**CHARLOTTE DOUGLAS INTERNATIONAL AIRPORT
CHARLOTTE, NORTH CAROLINA**

ADDENDUM NO. 1

**NORTH END AROUND TAXIWAY (NEAT)
OVERLOOK RELOCATION**

**CLT PROJECT NO. AVIA 23-50
ADDENDUM DATE: MAY 16, 2023**

DESIGNED BY:	STV ENGINEERS
PROJECT NO.:	4020901837-5
DRAWN BY:	CEG
CHECKED BY:	GHM
DATE ISSUED:	05/15/2023
REVISIONS	DATE
1 ADDENDUM NO. 1 - ADDED ENTIRE SHEET 3A-10	05/15/2023
2	
3	
4	
5

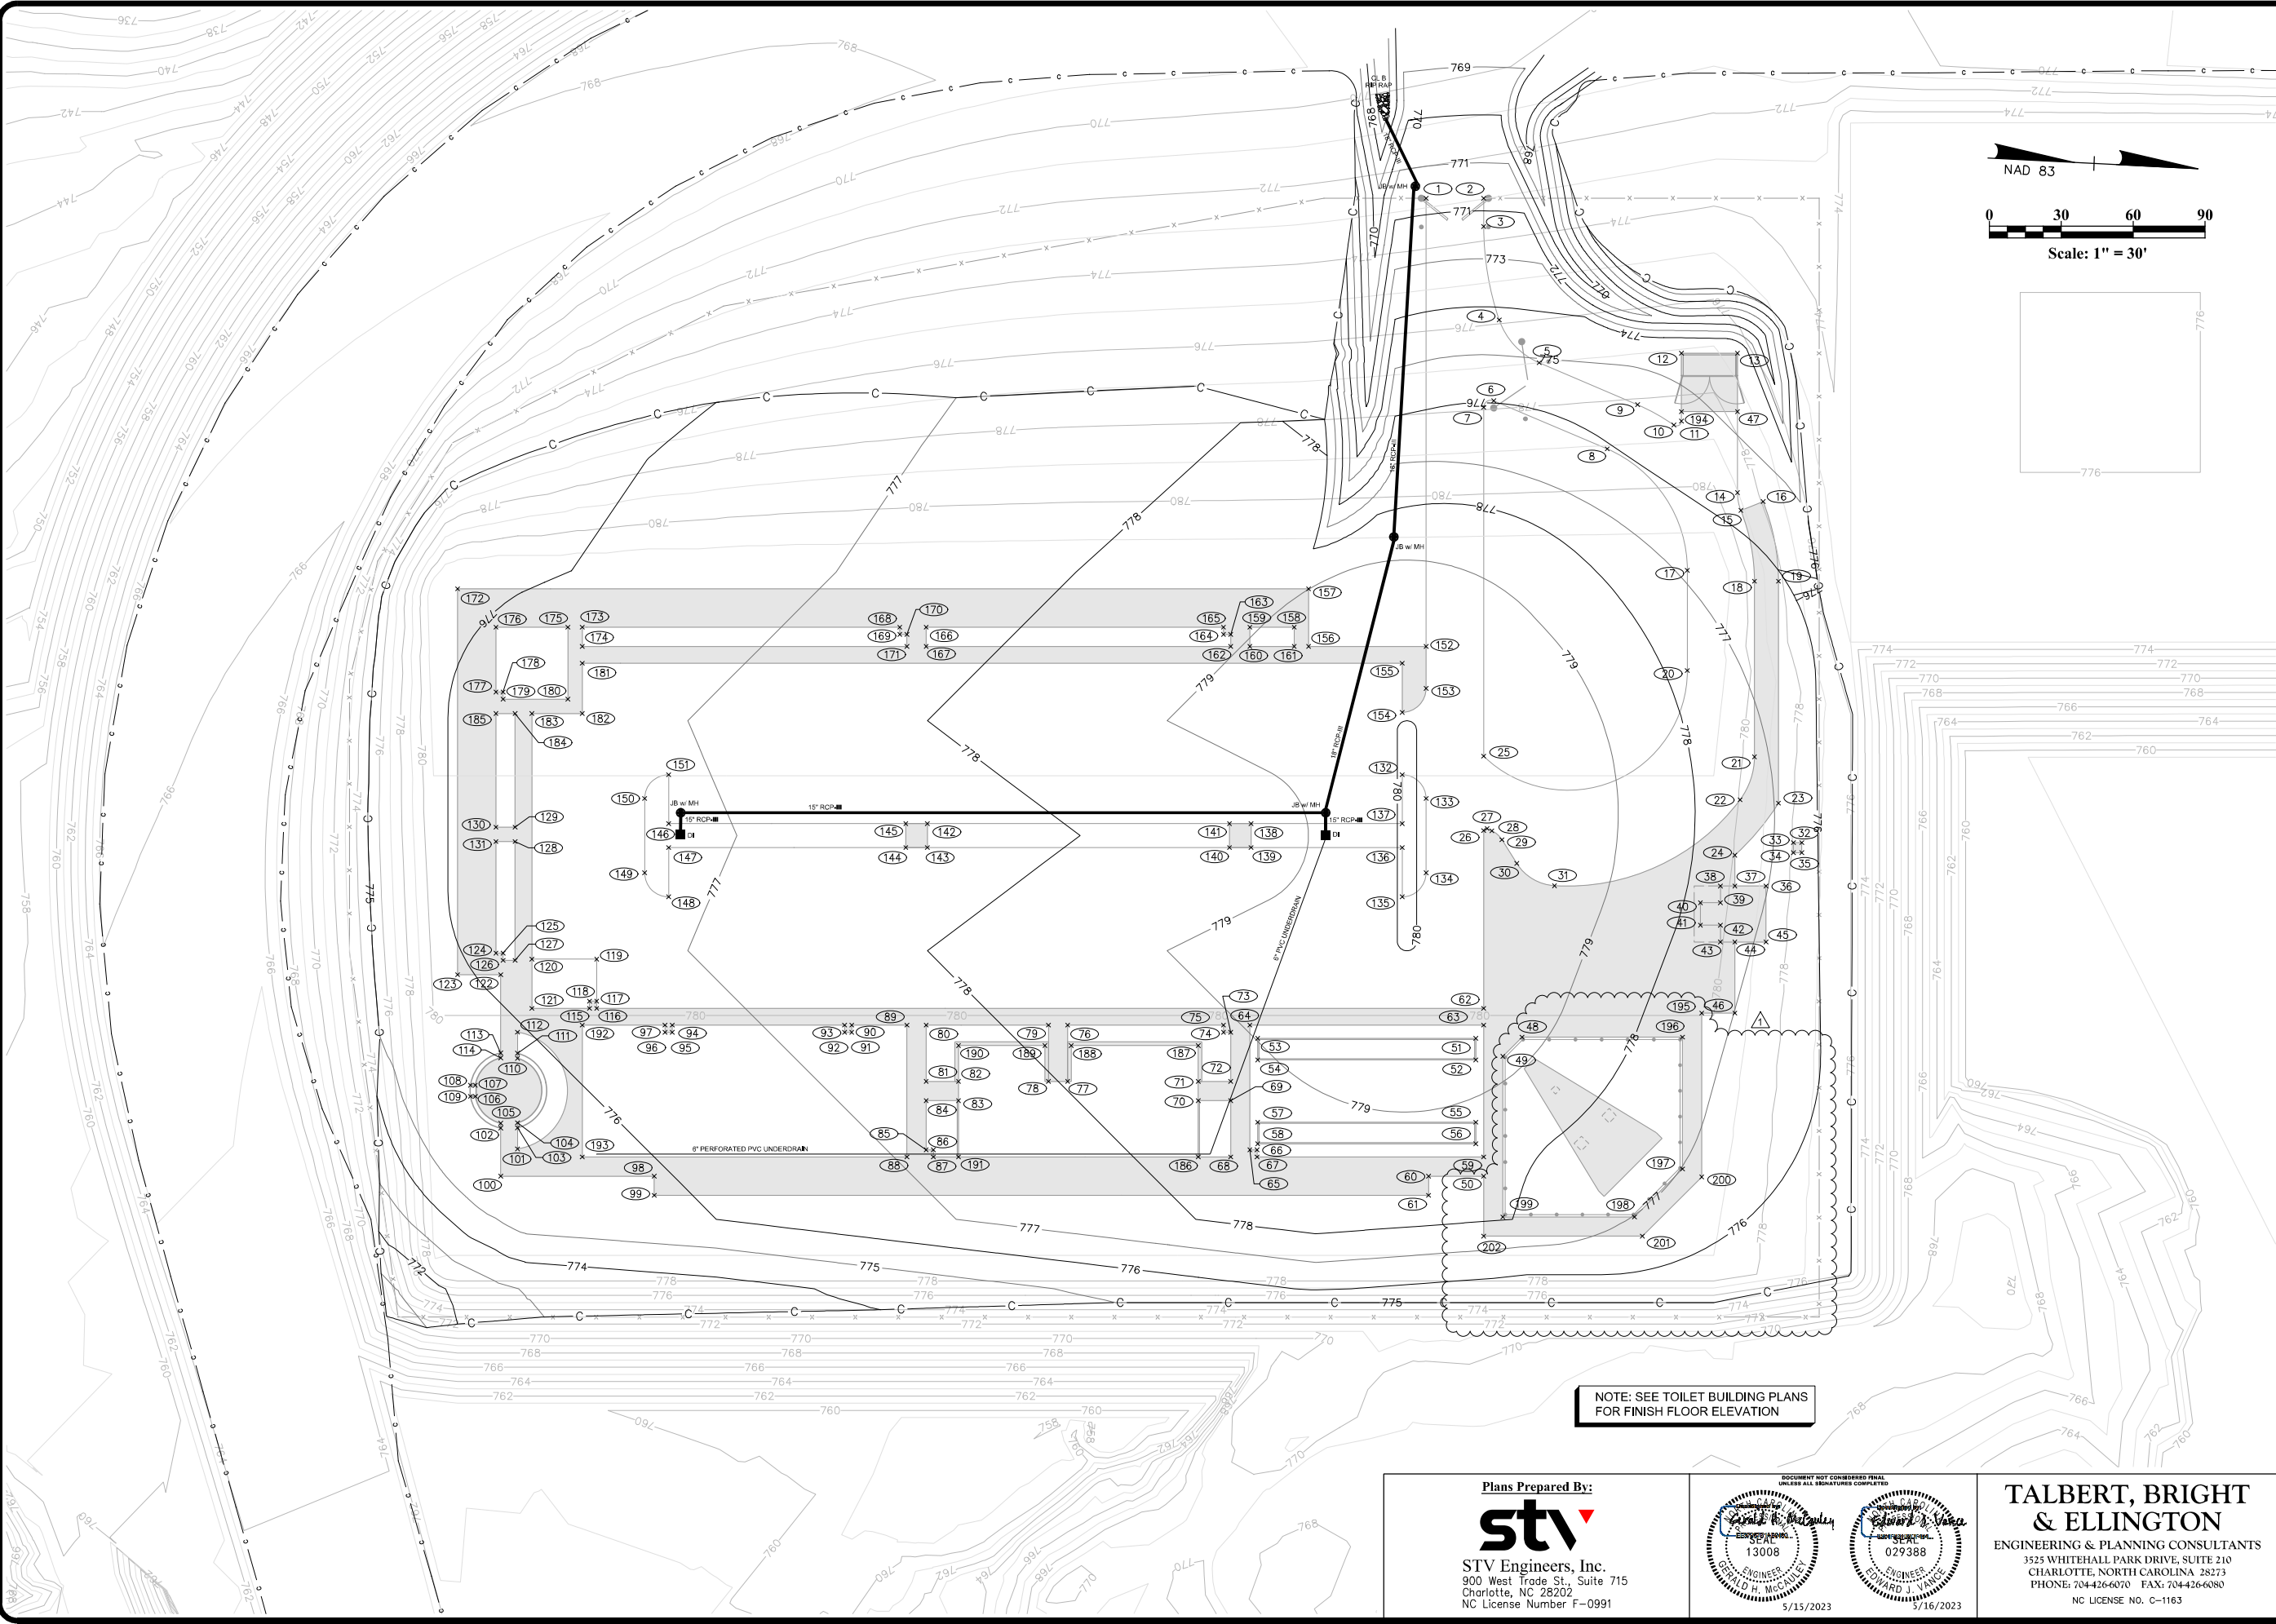
DATE	05/15/2023
REVISIONS	1 ADDENDUM NO. 1 - REVISED AIRCRAFT DISPLAY AREA
2	
3	
4	
5

1 ADDENDUM NO. 1 - ADDED SHEET S-2

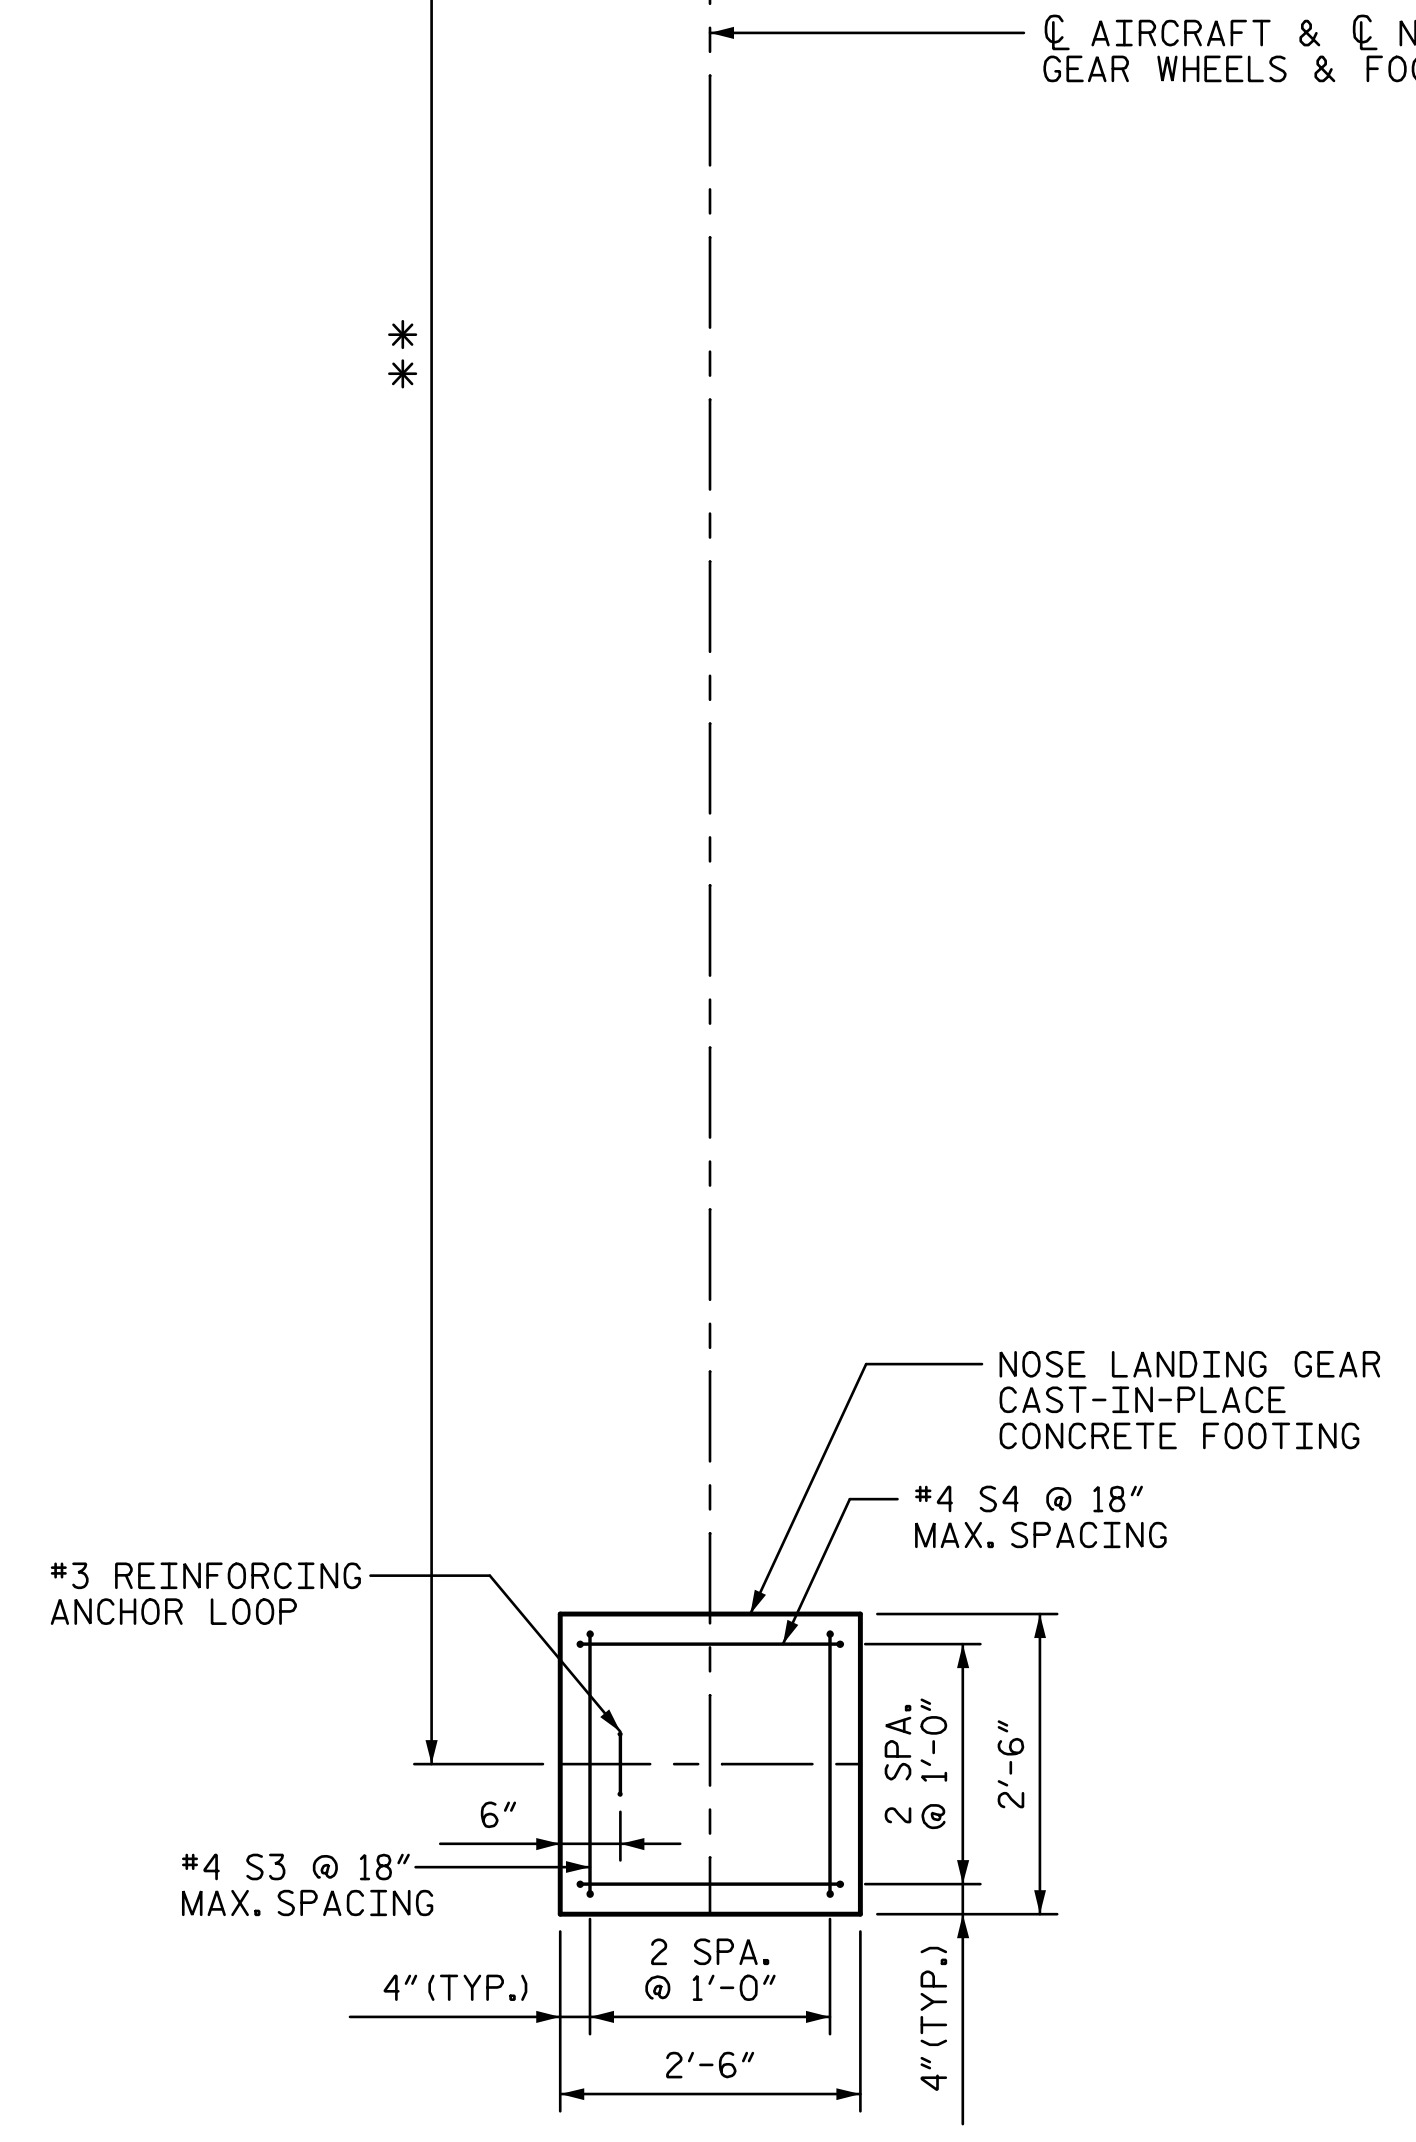
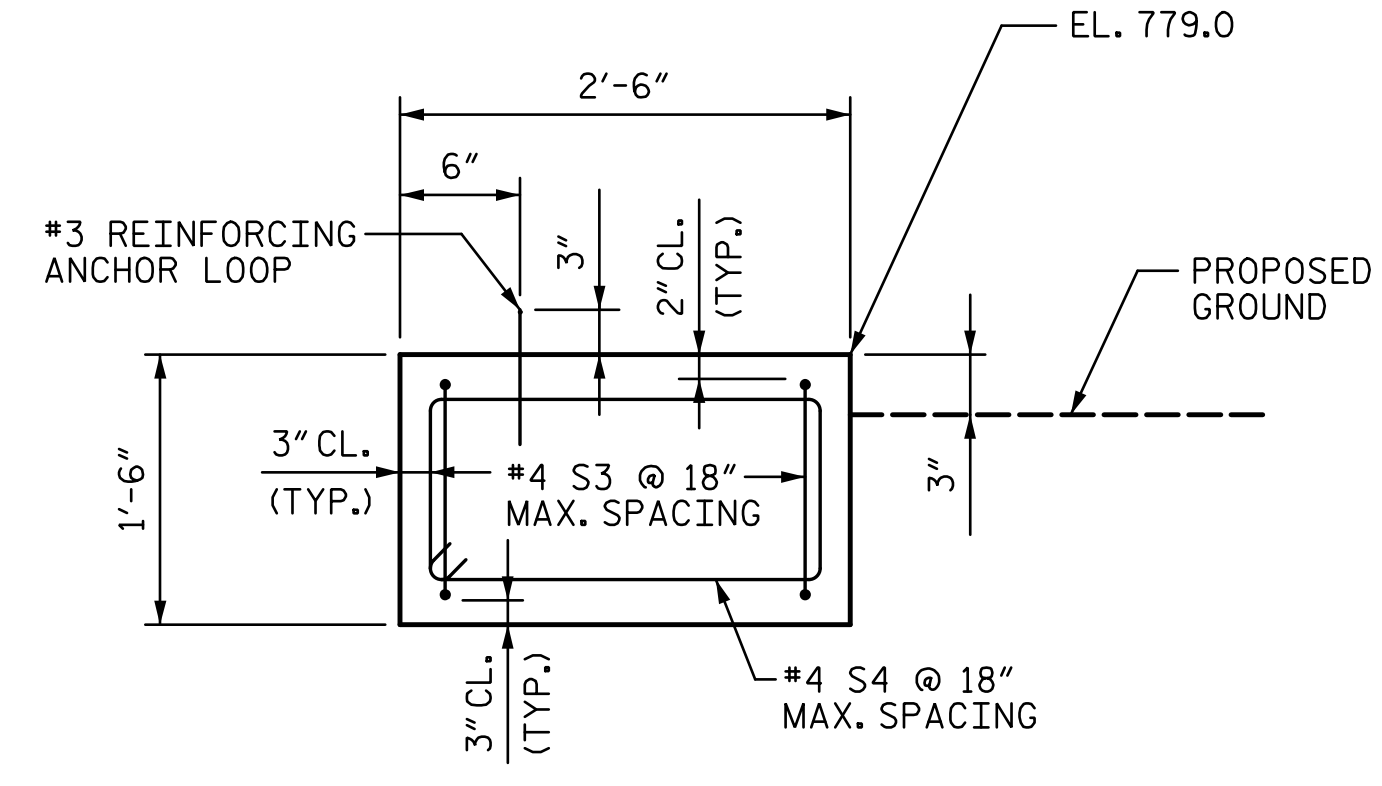
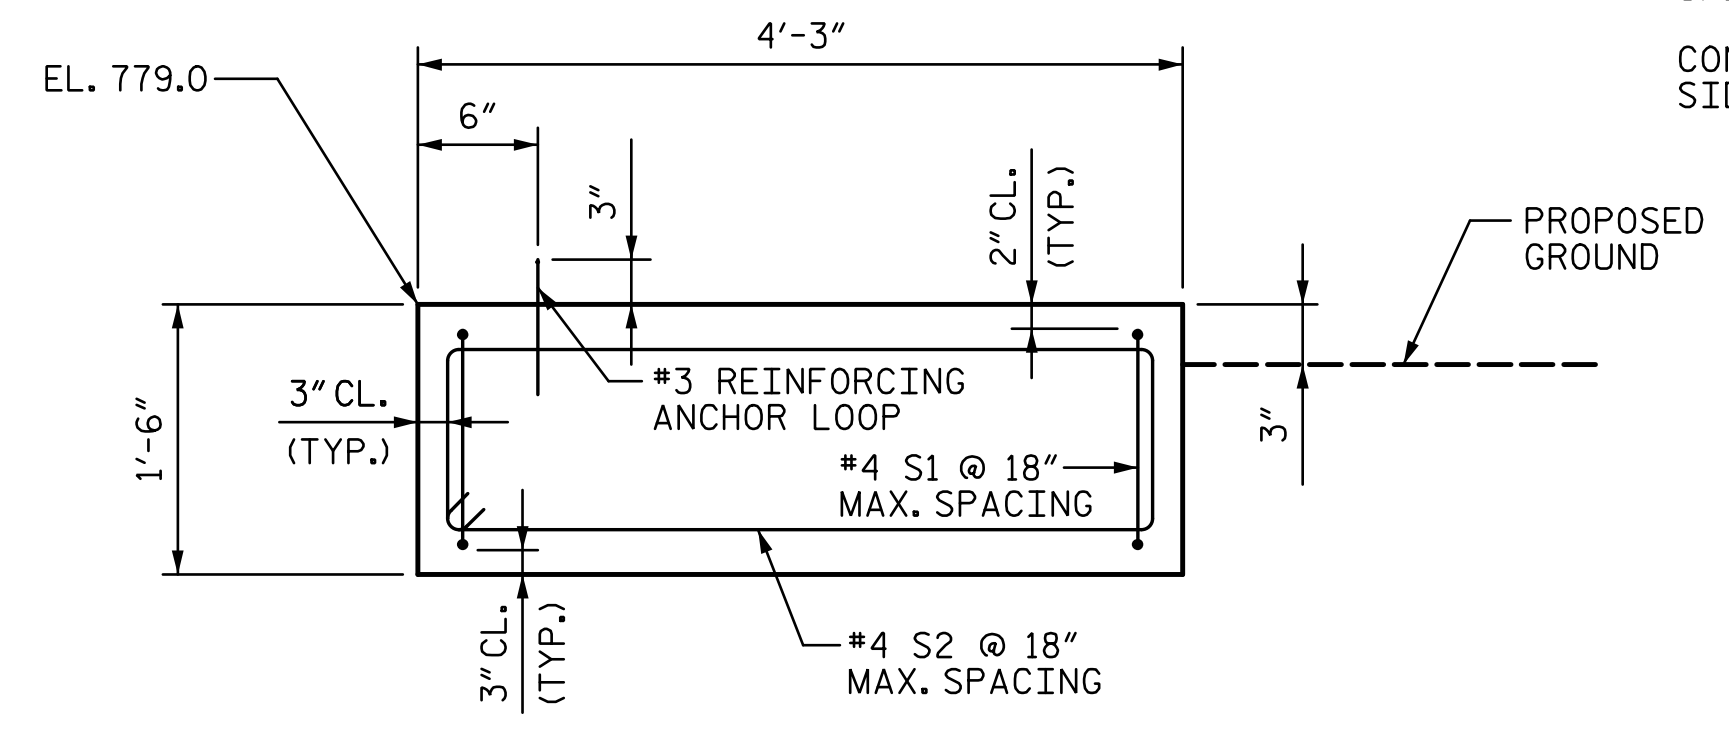
4. Will design loading criteria for the aircraft display be given, or is design loading a contractor design responsibility as well?
Addendum 1 removes the foundation design from the Contract. A line item for the foundation has been added.
